**CITY OF SAUSALITO**  
420 Litho Street, Sausalito, CA 94965

**Addendum No. 2**

Issued **June 14, 2023**

**For**  
**Bridgeway Slide Repair Below 268 Woodward Project**

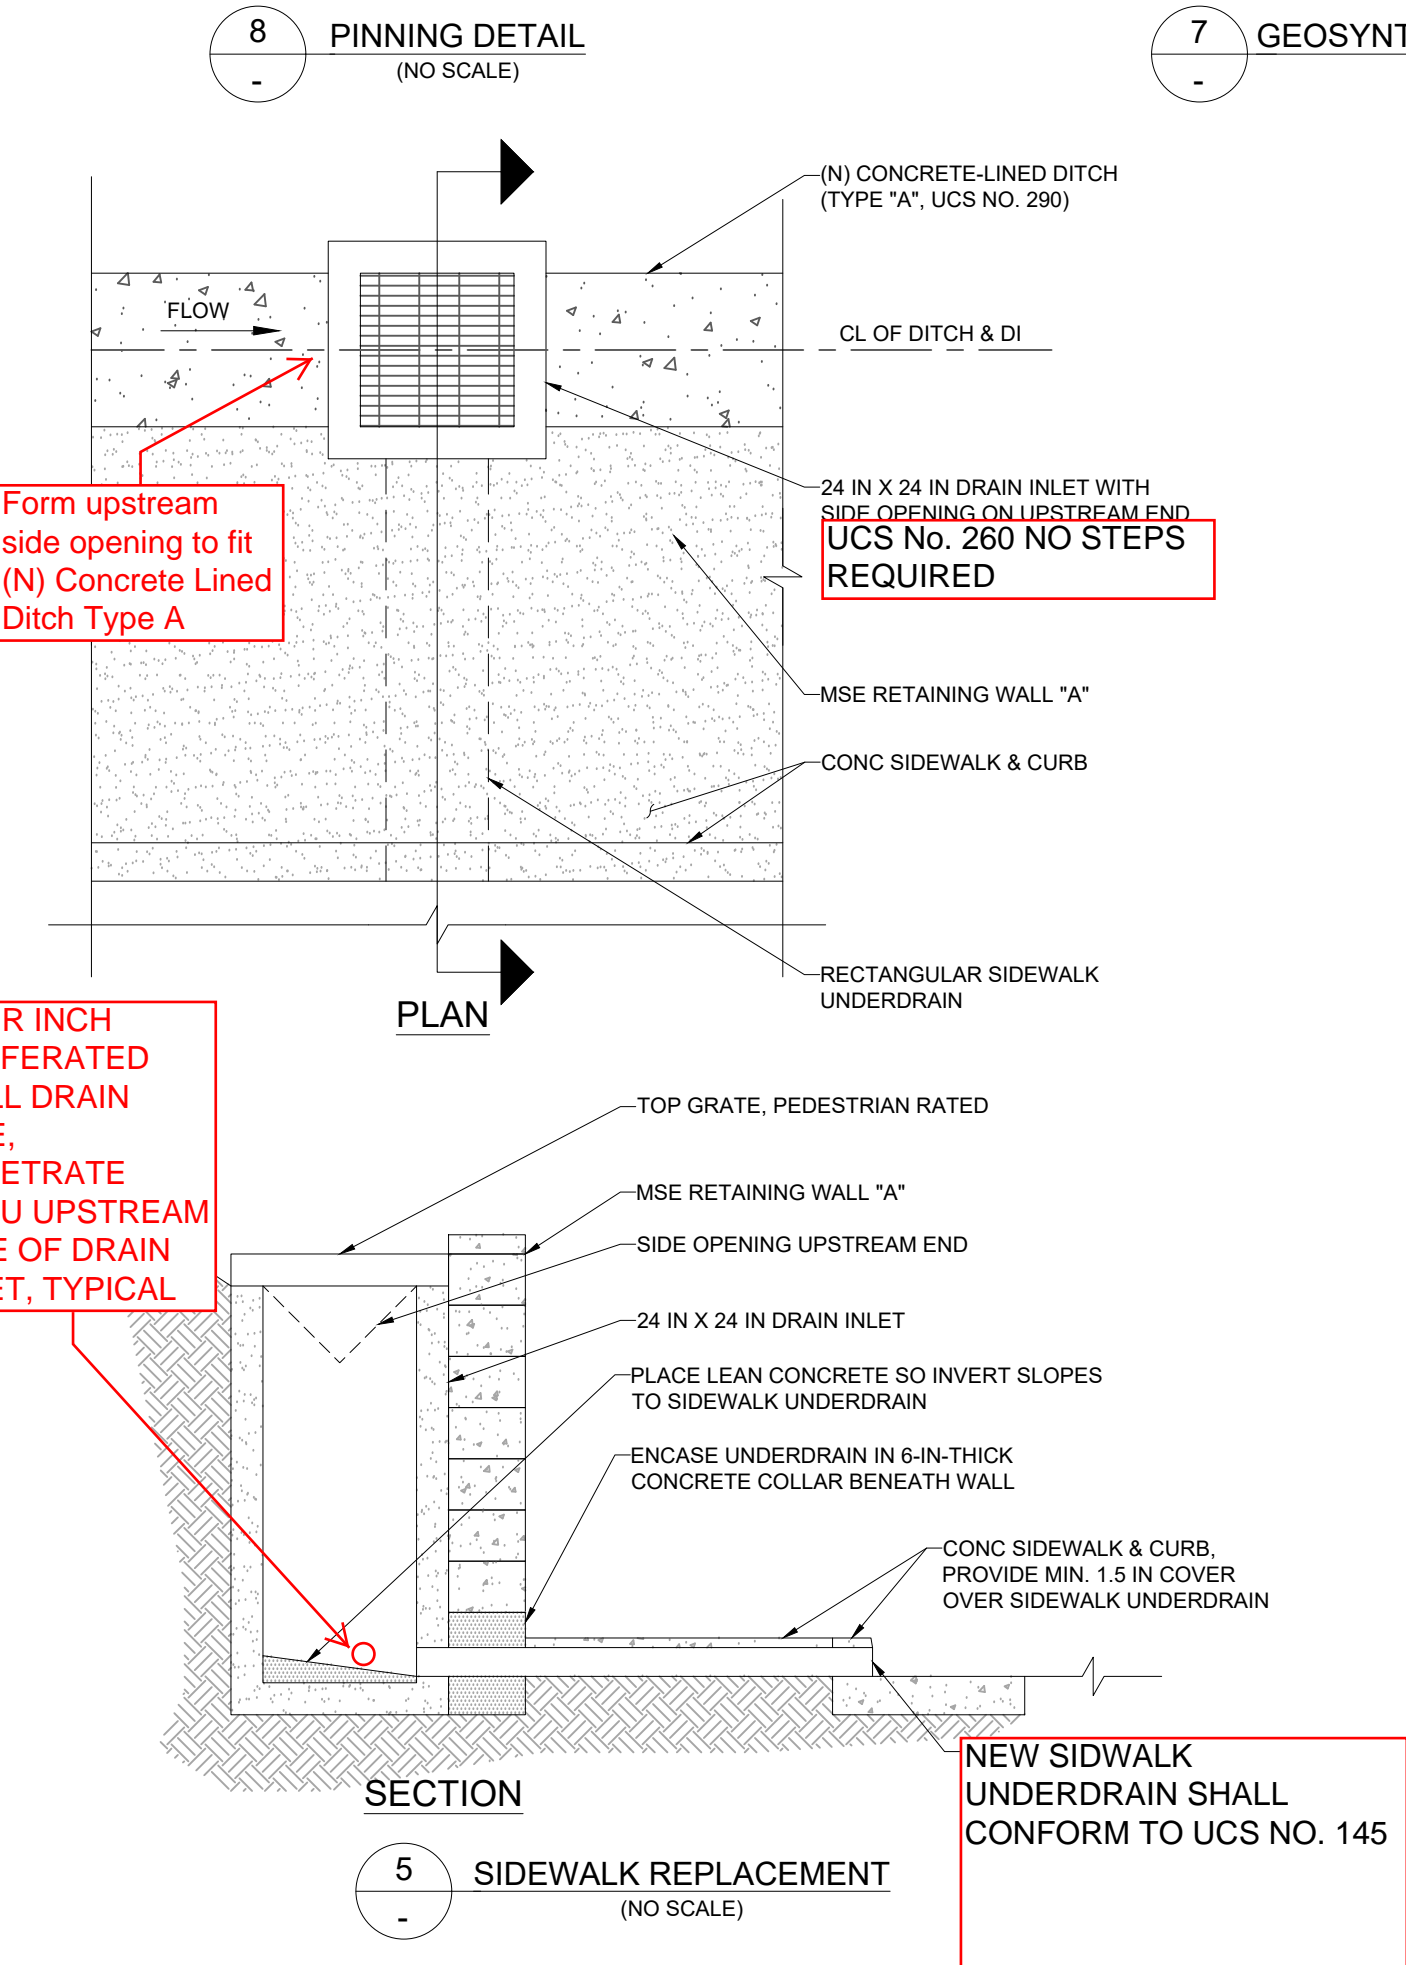
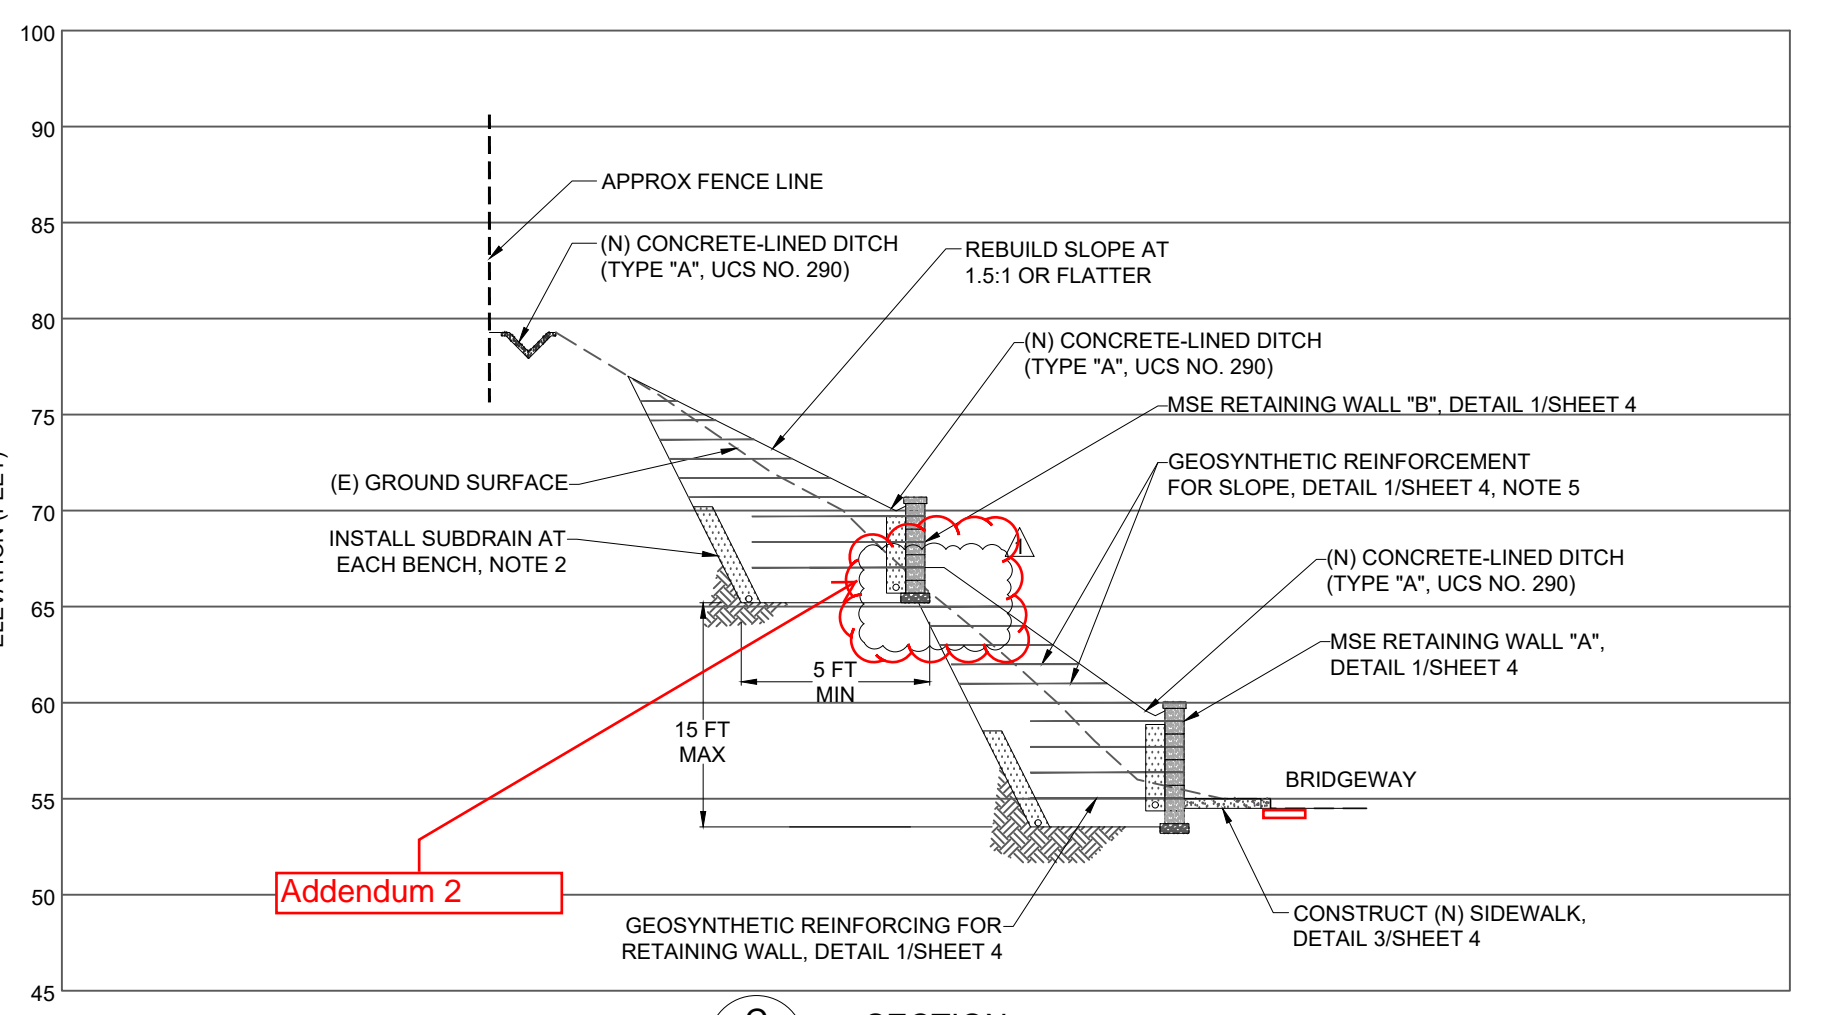
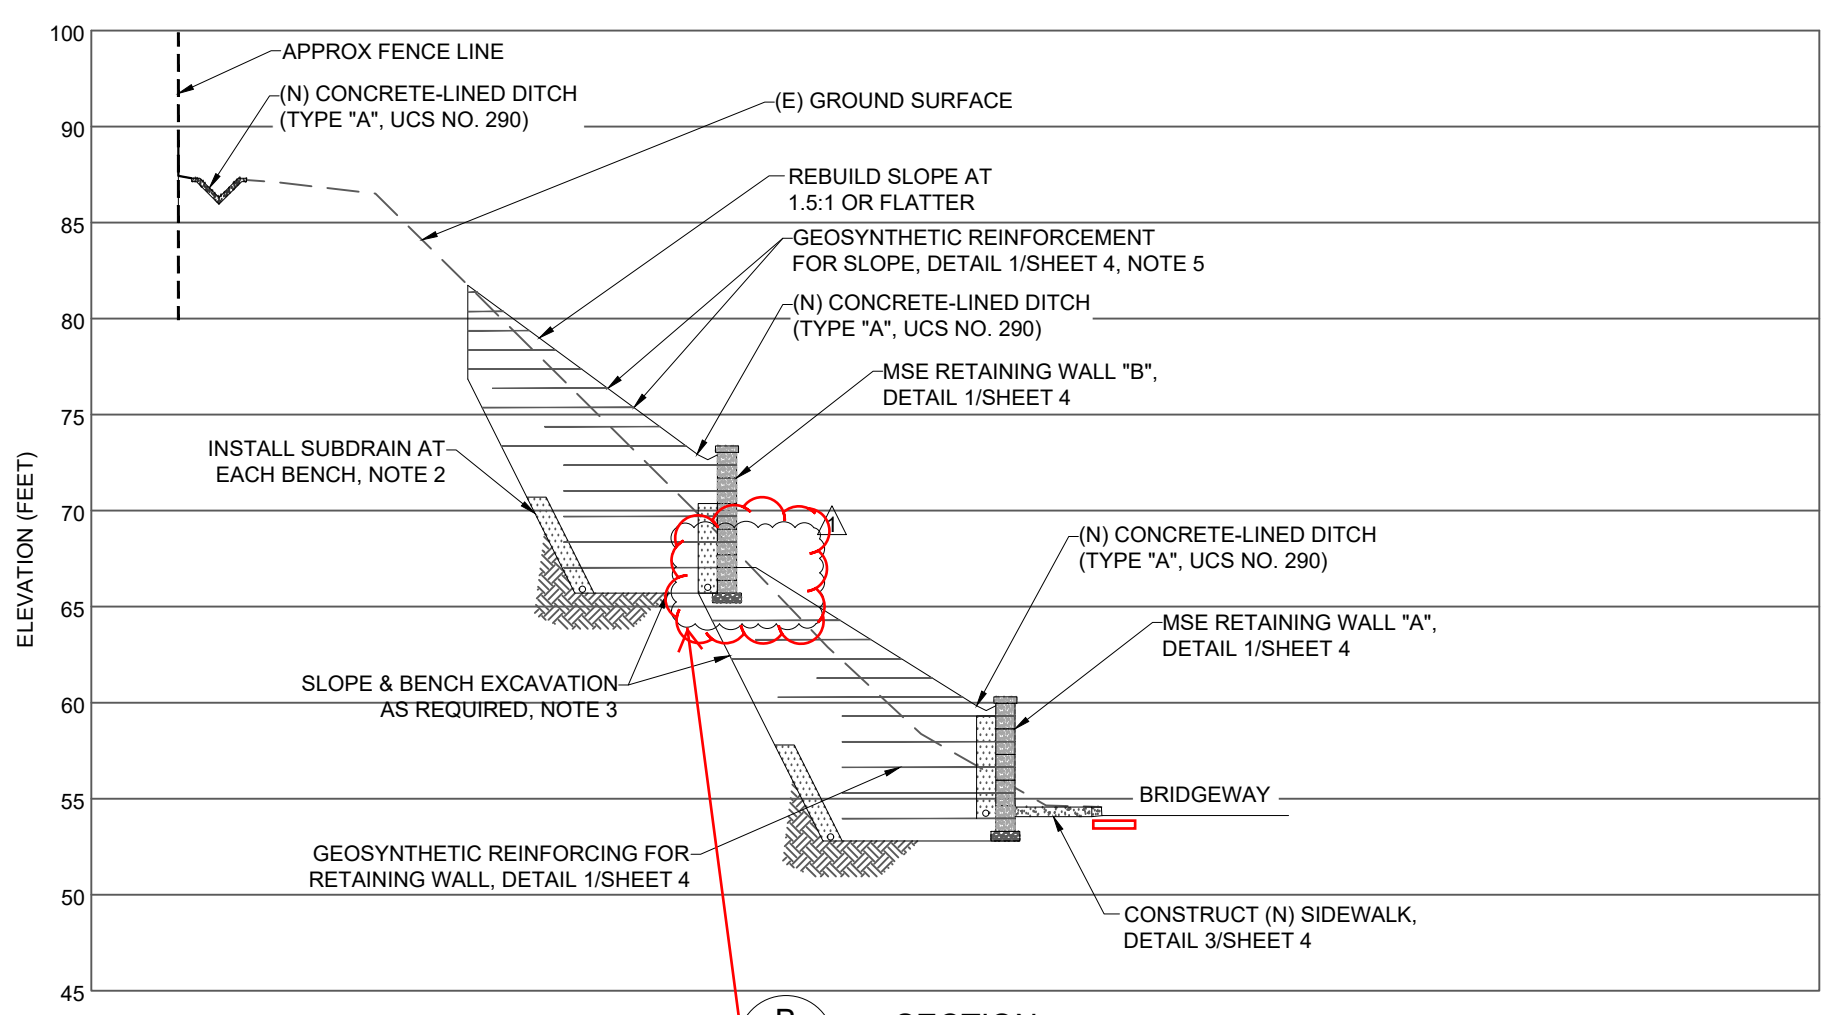
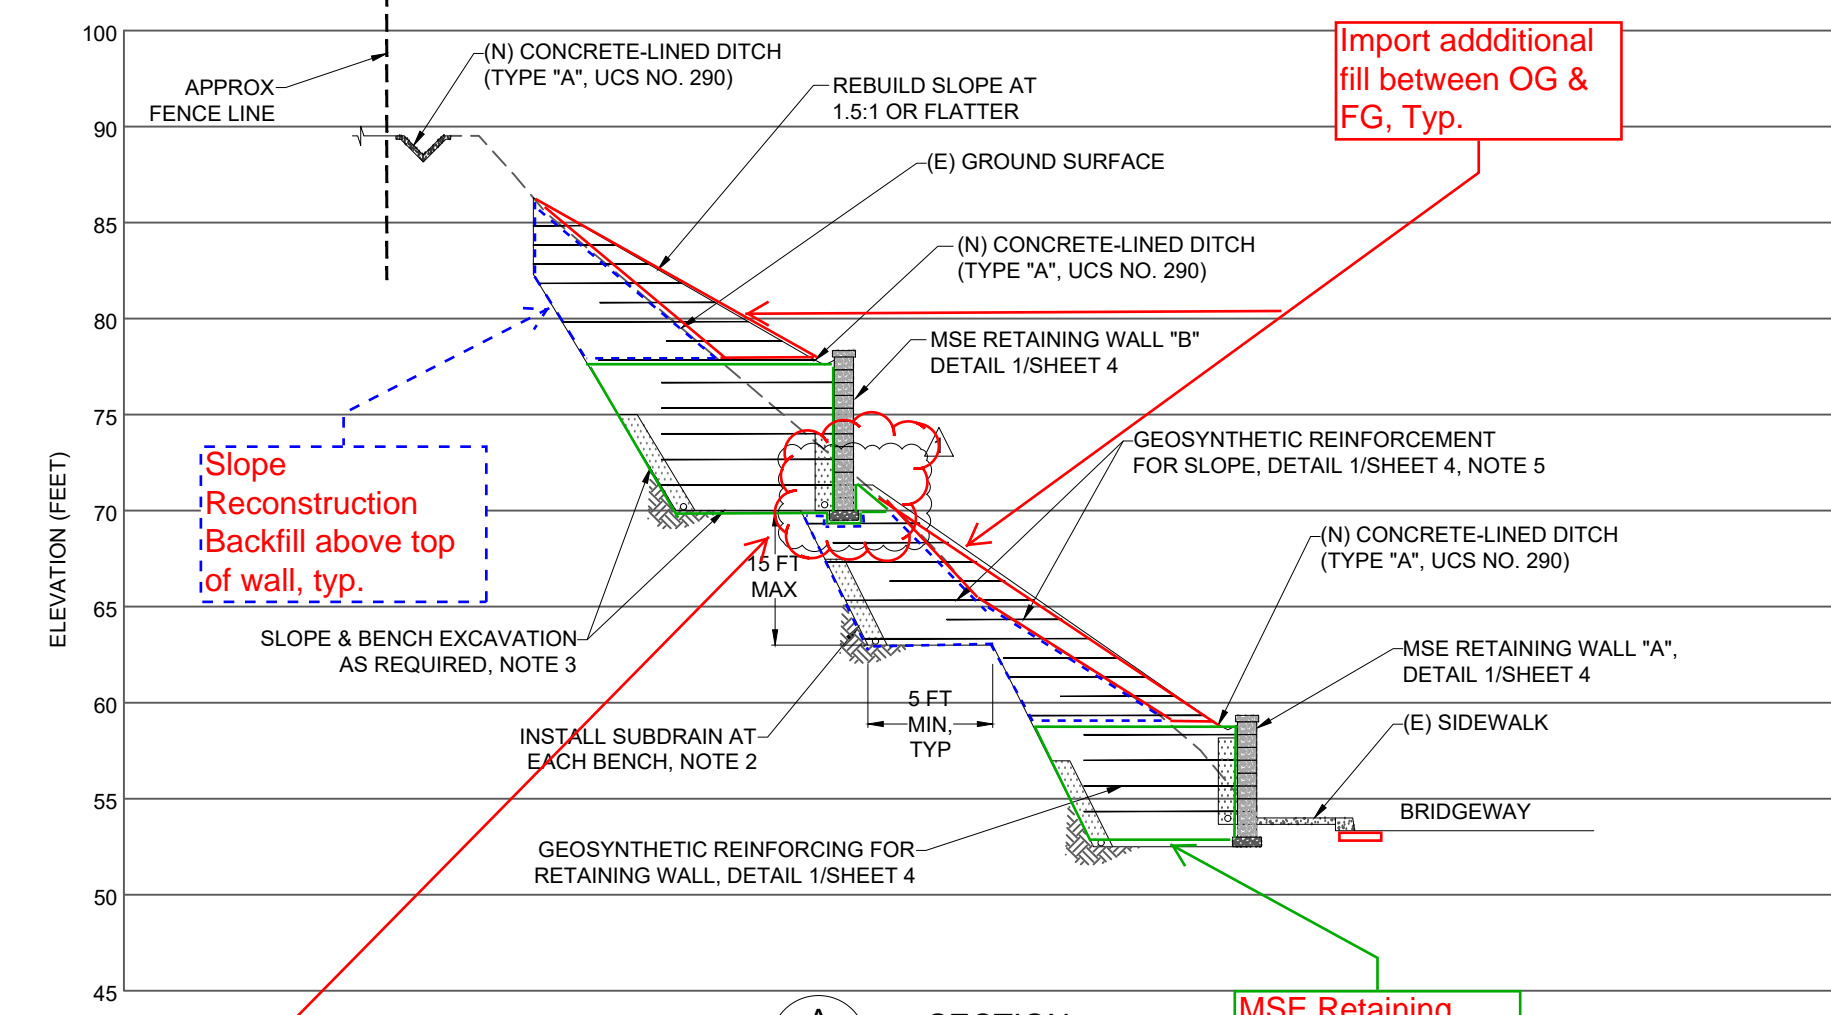
1. Sheets 1 and 4 have been revised and are attached. See clouded revisions, called out as "Addendum 2".
